Subject **Dundee, Gambo, Little Falls, Mallison Falls, and Saccarappa Projects**
FERC Project Nos. 2942, 2931, 2941, 2932, and 2897
Operations and Flow Monitoring Plan

FINAL OPERATIONS AND FLOW MONITORING PLAN

The DEP has reviewed your letter of May 26, 2004 and the accompanying Draft Operations and Flow Monitoring Plan for the Presumpscot River Hydro Projects (Dundee, Gambo, Little Falls, Mallison Falls, and Saccarappa), submitted on behalf of SD Warren Company. This plan has been prepared in compliance with Articles 401, 402, 403 and 404 of the FERC licenses (No. 2942, 2931, 2941, 2932, and 2897) for the projects and Conditions 1, 2, and 6 of the Water Quality Certification for the projects.

FIGURE 1

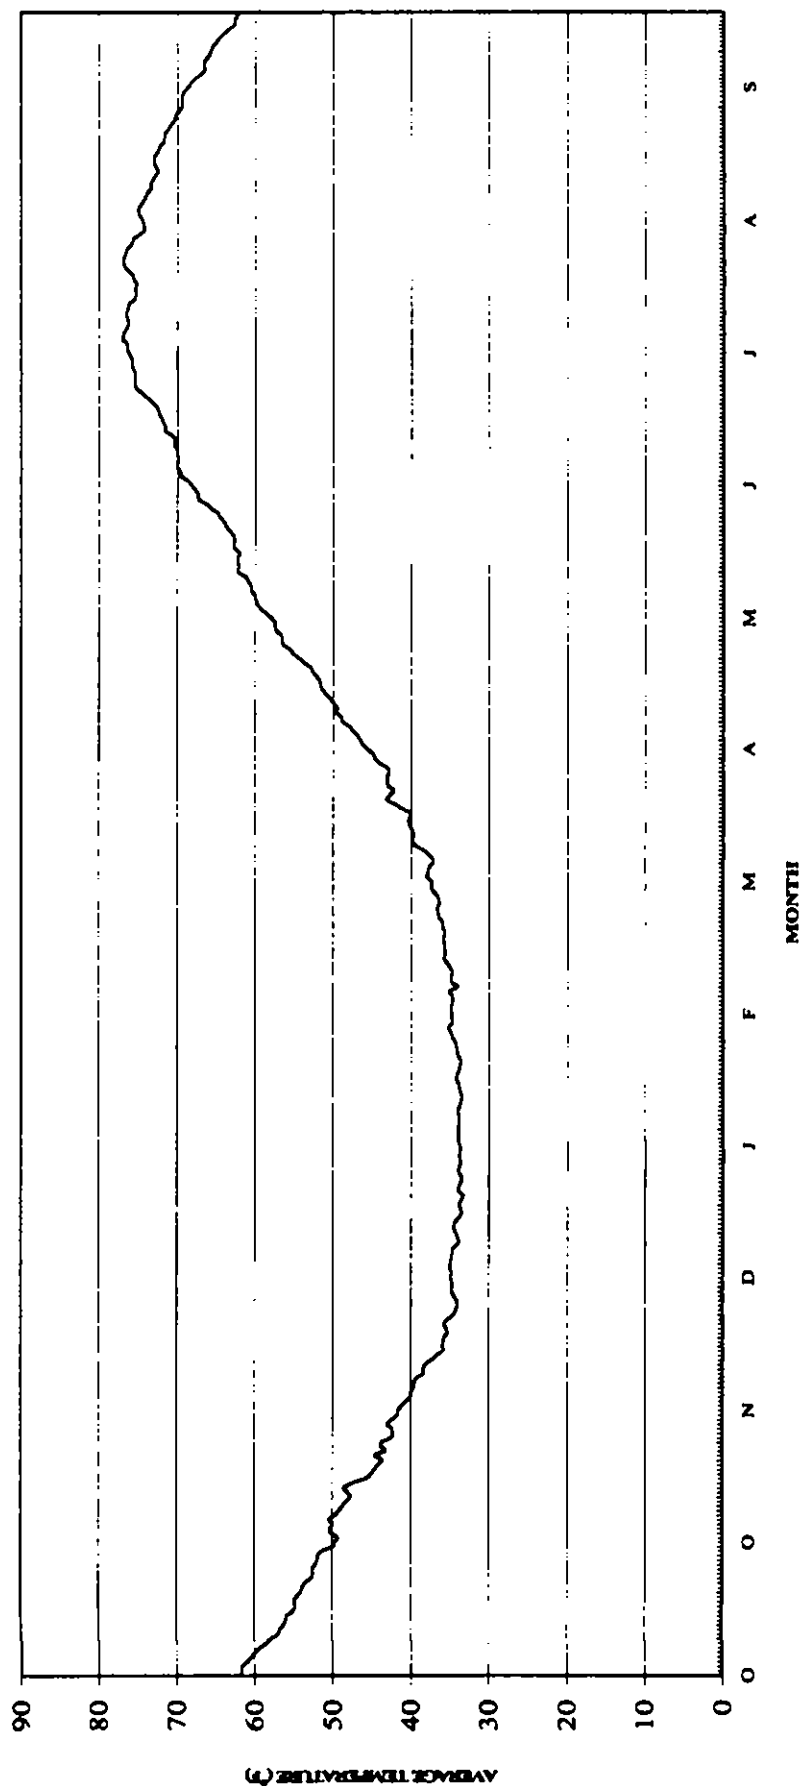
7. Figure 1, "Average Daily Temperature in the Presumpscot River As Recorded in the USGS Water Quality Gage Near West Falmouth, Maine (Gage No. 1064140) For Period of Record 1976-93," appears to be incorrectly labeled on its x axis.
